Dane County, Wisconsin
Telecommunications Site Review
New Support Structure

August 25, 2017

RE: Dane County
Verizon Wireless / Jenna Drive

Exhibit A - Proposed Support Structure

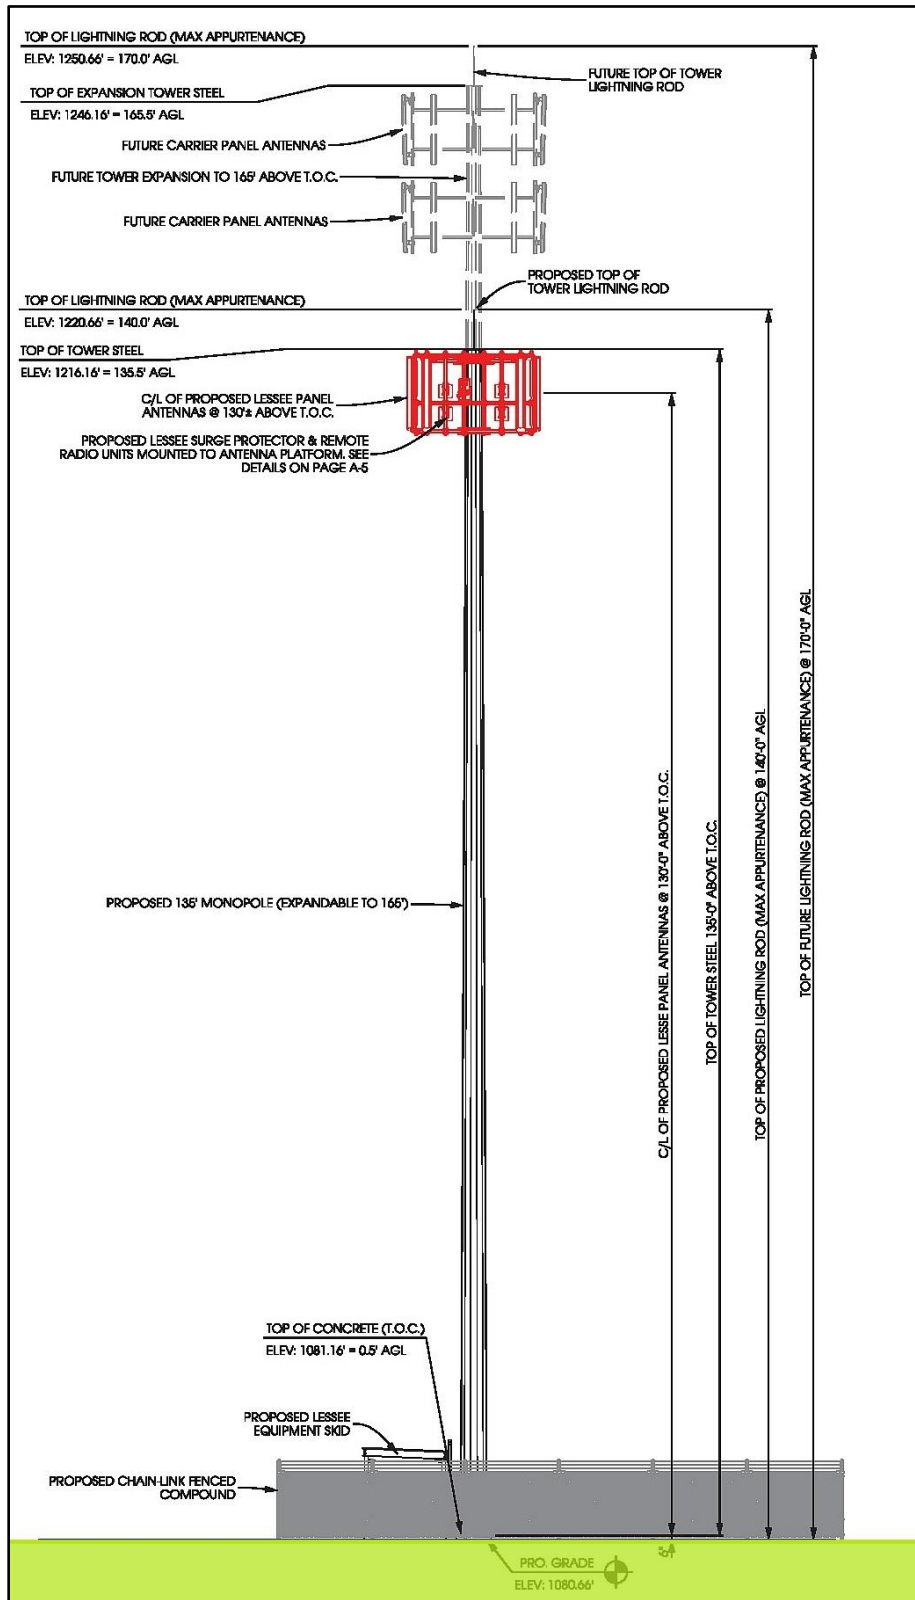
be able to accommodate at least two (2) collocations (three (3) total arrays). The Applicant is proposing three (3) future collocations, at 115 feet, 145 feet and 160 feet. However, the tower elevation drawing, *in Appendix Exhibit A*, does not depict the 4th array at 115 feet. Typically, arrays are spaced 10 feet apart. A structural letter from the tower manufacturer was provided for an overall height of 165 feet, but the number and location of the collocations is not included. The structural report should include the proposed equipment on the tower (i.e., number of antenna arrays).

CityScape agrees that designing the tower for 3 future collocations is better than the County's requirement of two. CityScape also believes that the future collocations could be spaced 10 feet apart, at 120, 140 and 150 feet, requiring the tower design to only be 155 feet in overall height (160 feet with lightning rod). This would be a future 20-foot increase which could be part of the streamlining process. This is only being noted now so that the structure is properly designed for arrays at these heights (with access ports at these heights).

1. All feed lines shall be installed within the support structure and antenna ports shall be sealed in a manner to prevent access by birds and any other wildlife; and,
2. Proposed tower shall be galvanized and not painted any other color without approval of the City; and,
3. Applicant shall not begin construction until Federal SHPO/NEPA requirements are met; and,
4. County may wish to require some level of landscaping for the southern and western edges of the compound if adjacent development is proposed; and,
5. Prior to construction, the tower manufacturer letter should be revised to indicate the tower will be designed to accommodate three (3) total antenna arrays (of like design to the Applicant's).
